Z-59
(2013)

PROJECT
VILLAGE GREEN AT
EAST COBB

PETITION NO.: Z-59

ZONING COMMENTS:

SITE PLAN
SCALE

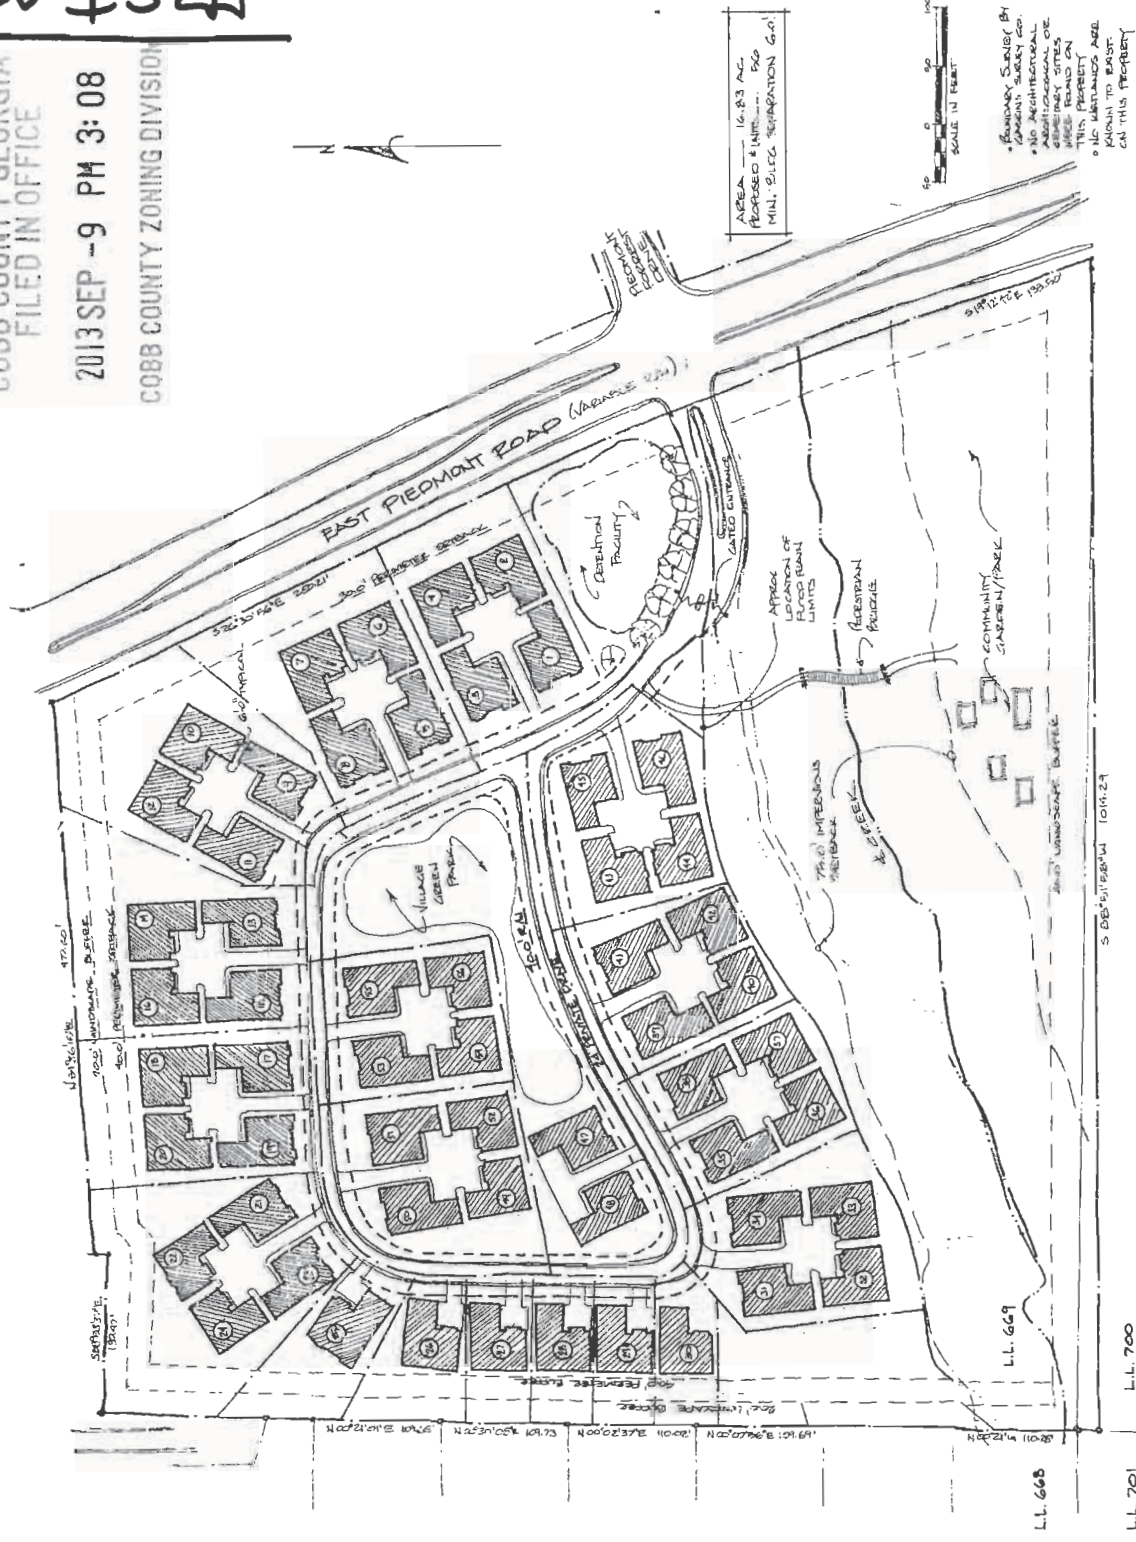
- Provide comprehensive hydrology/stormwater controls to include development of out parcels.
- Submit all proposed site improvements to Plan Review.
- Any **spring activity** uncovered must be addressed by a qualified geotechnical engineer (PE).
- Structural fill _____ must be placed under the direction of a qualified registered Georgia geotechnical engineer (PE).
- Existing facility.
- Project must comply with the Water Quality requirements of the CWA-NPDES-NPS Permit and County Water Quality Ordinance.
- Water Quality/Quantity contributions of the existing lake/pond on site must be continued as baseline conditions into proposed project.
- Calculate and provide % impervious of project site.
- Revisit design; reduce pavement area to reduce runoff and pollution.

- No Stormwater controls shown _____
- Copy of survey is not current – Additional comments may be forthcoming when current site conditions are exposed.
- No site improvements showing on exhibit.
